Ref: PEG-1155-93M-CN-HI-BOA-LET-ES-10436
Jean Marc Decloquement
Consortium Director
Blocks 277-278,2nd business sector,
Teseen st, Shaker Consultancy Building
New Cairo, Egypt.

Project: Engineering, Procurement and Construction of the New Administrative Capital Monorail and 6th October City Monorail (Contract 93/Metro).

Subject: Comments on shop drawings. // 93M-BOA-NAT-LOT-26138

DRAWING TITLE
6TH OF OCTOBER MONORAIL
SHOP DRAWING FOR LINE SEGMENT (L00)
FRAME : FR-1

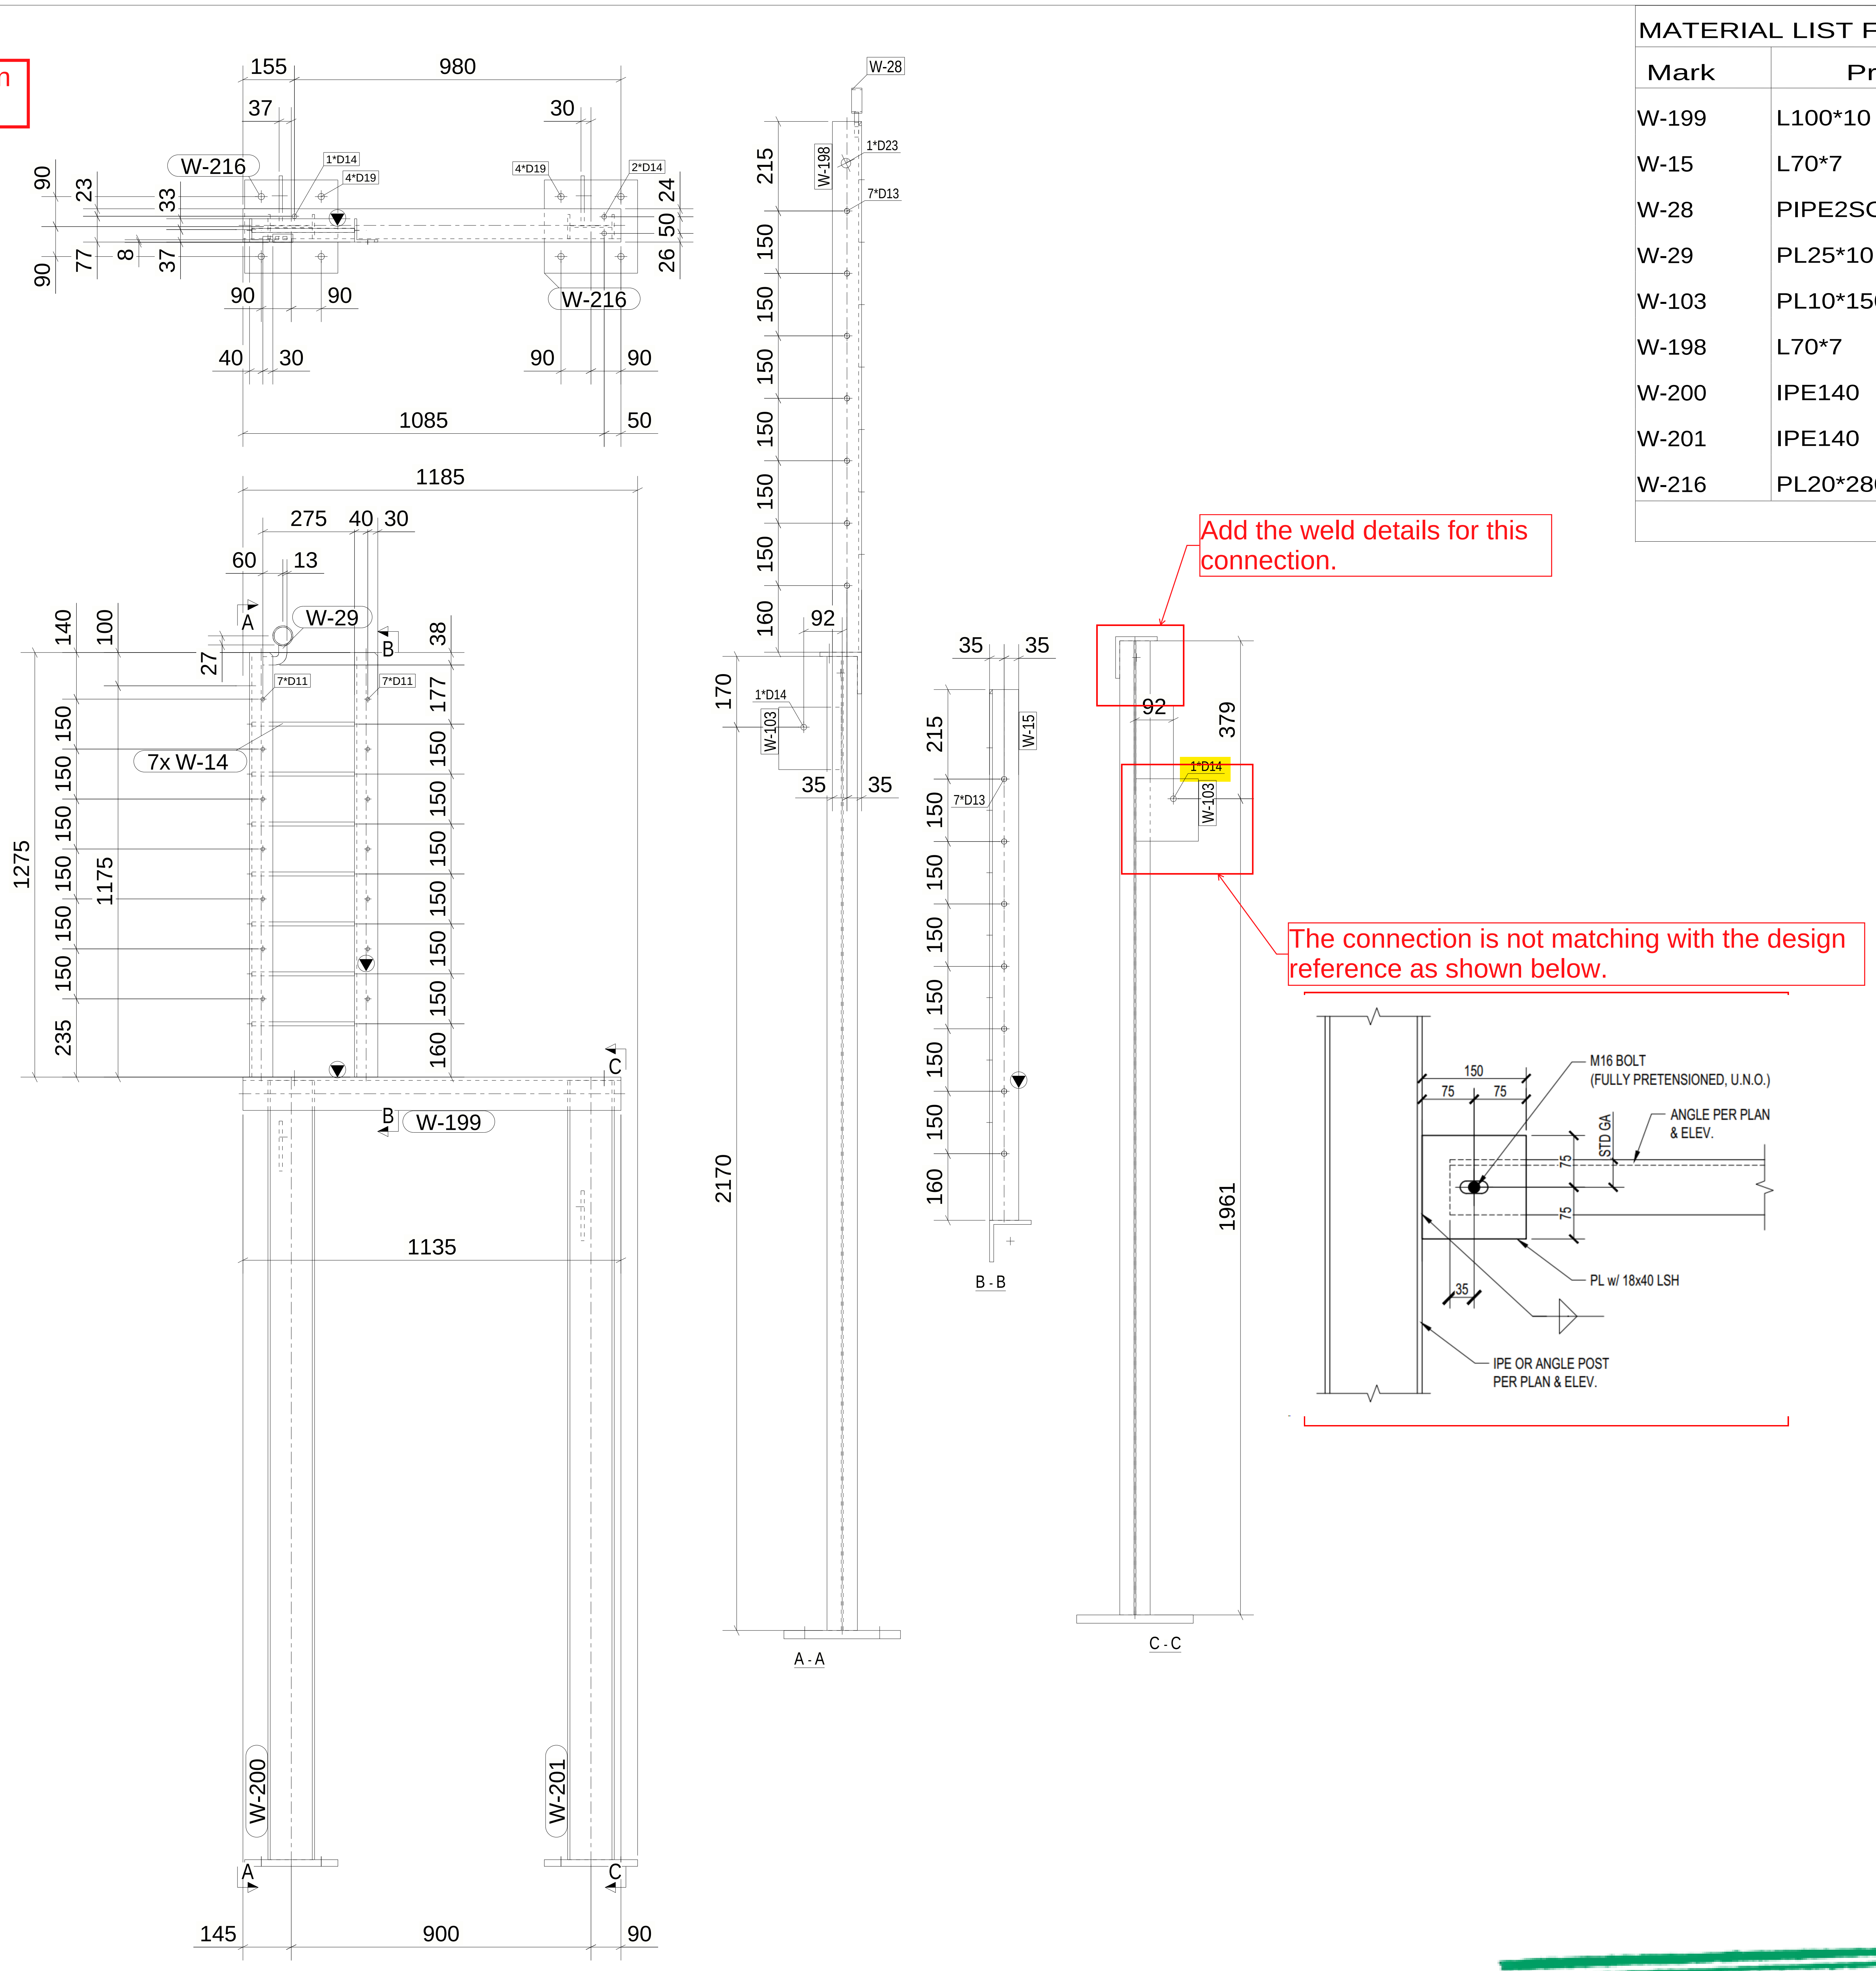
Add the weld details for this connection.

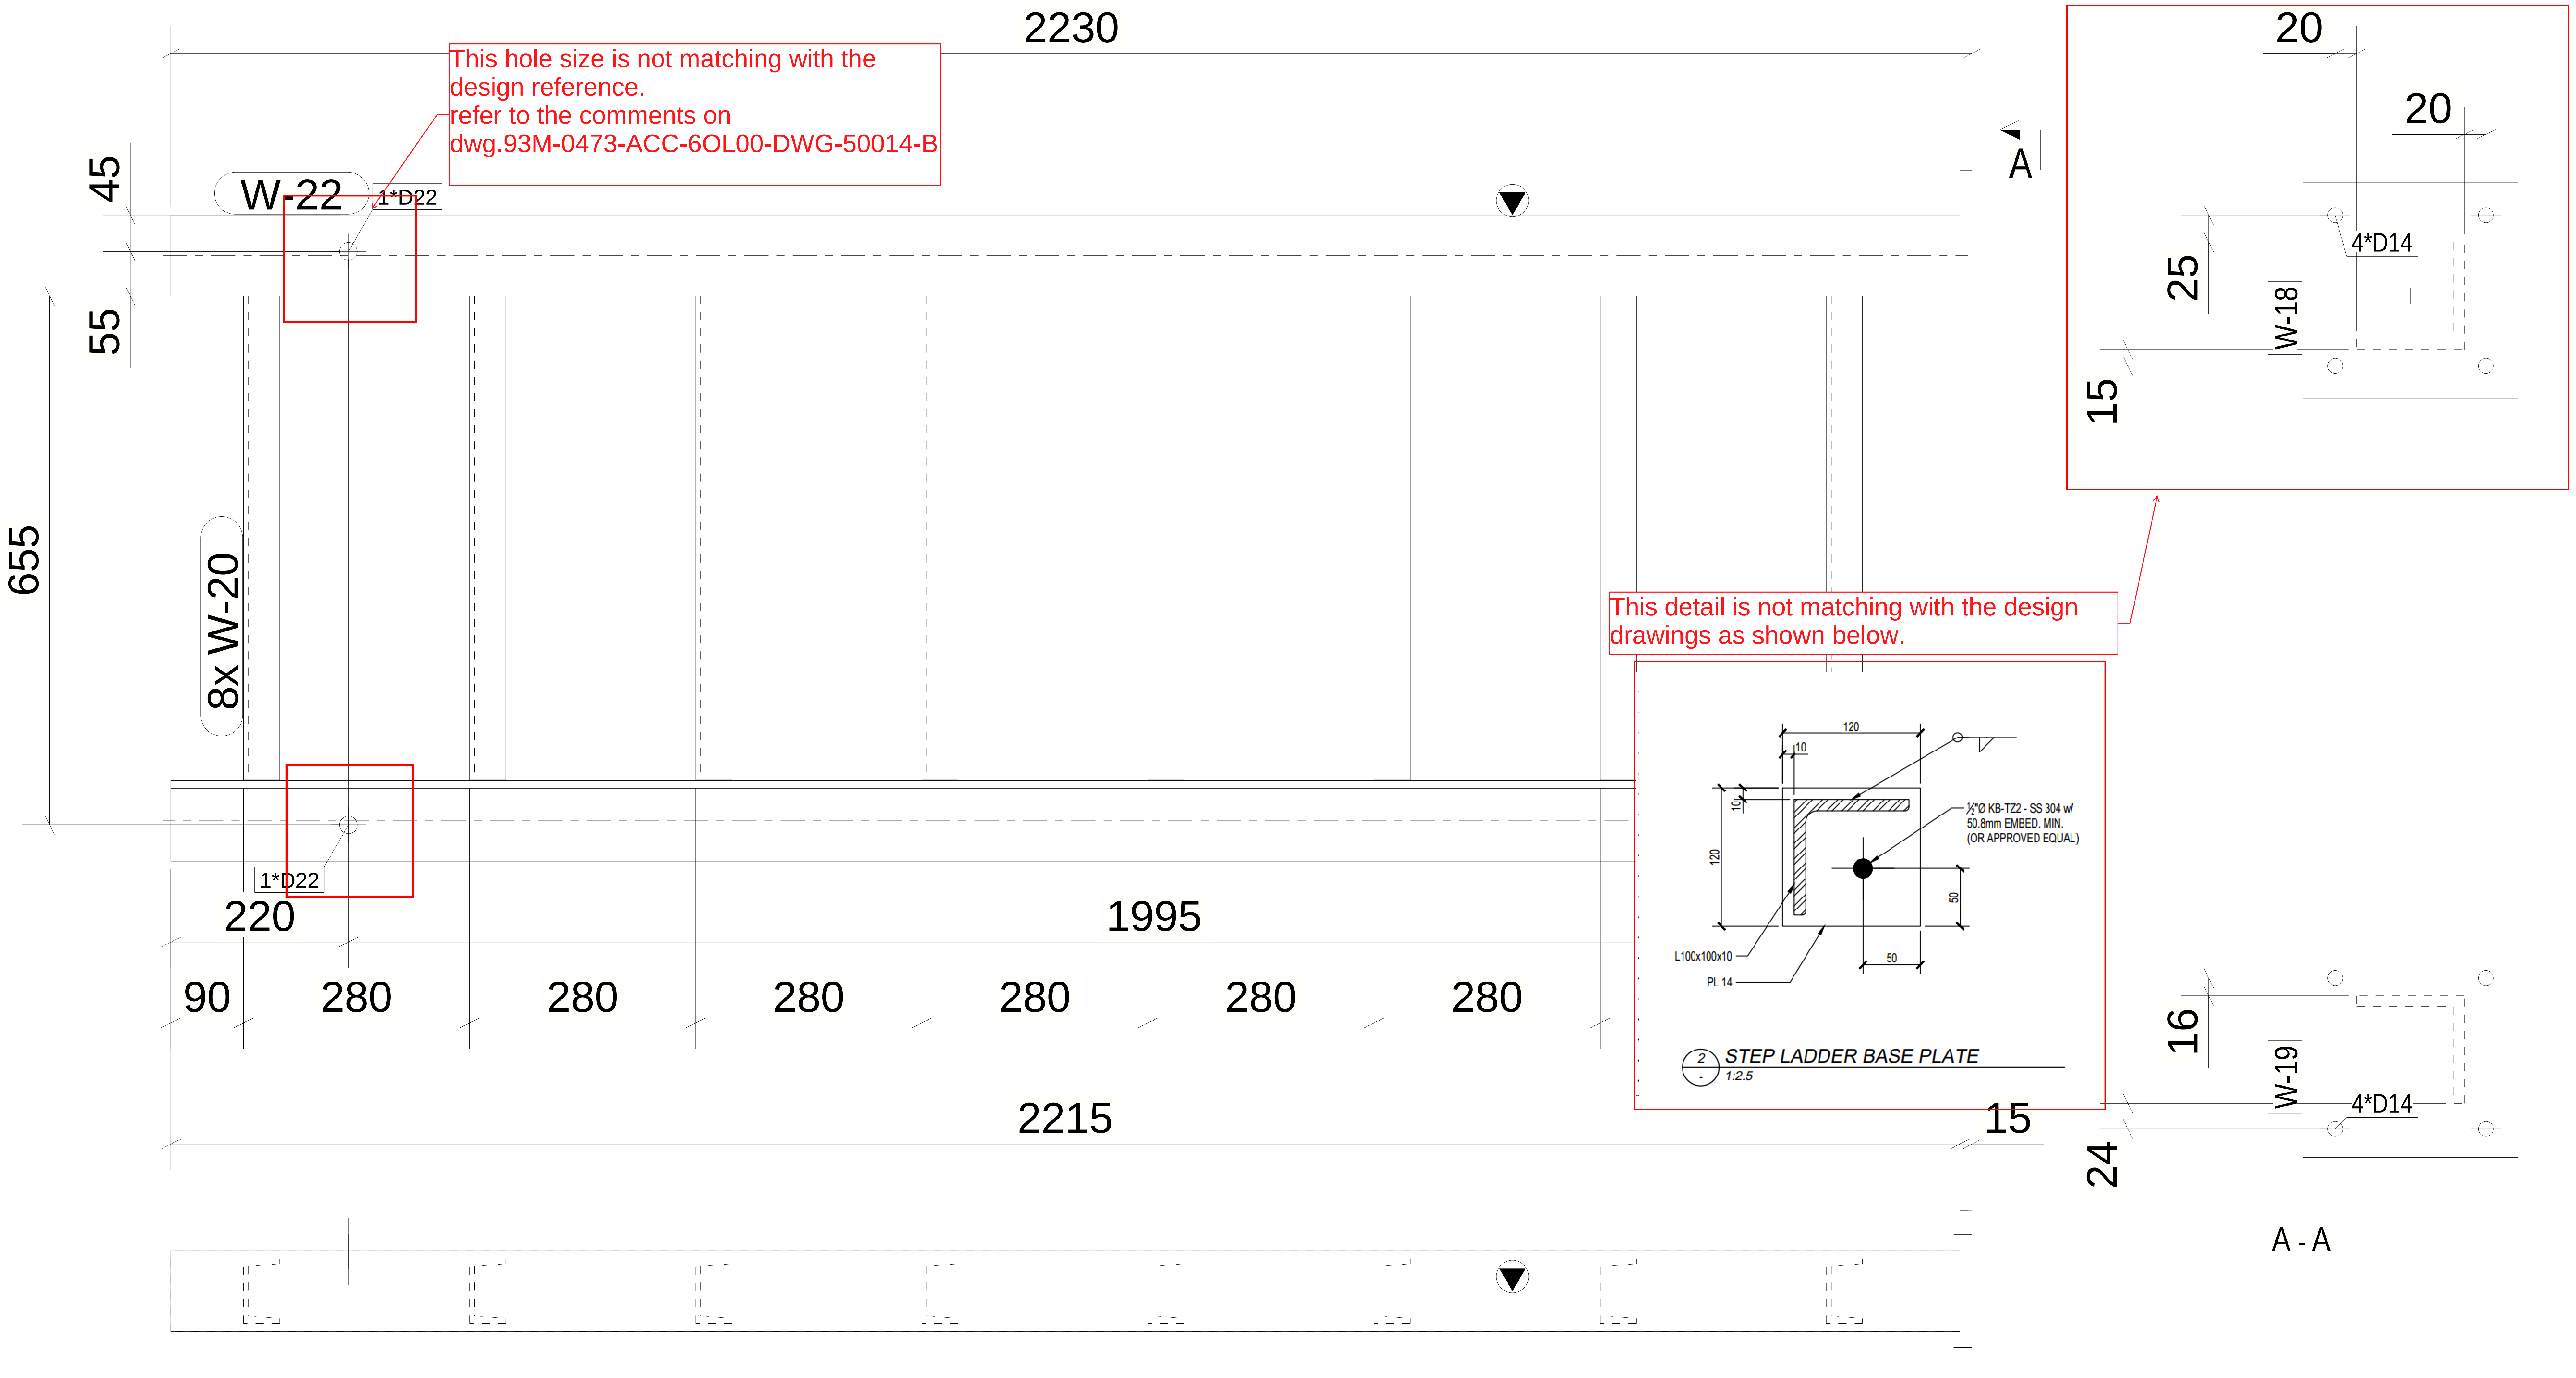
<table><tr><td></td><td></td><td>

W 22
1*D22
8x W-20
1*D22
220
90
280
This detail is not matching with the design drawings as shown below.

20
20
4*D14
25
W-18
15

120
10
20
120
½"Ø KB-TZ2 - SS 304 w/ 50.8mm EMBED. MIN. (OR APPROVED EQUAL)
50
50
L100x100x10
PL 14
2
STEP LADDER BASE PLATE
1:2.5
15
</td></tr></table>
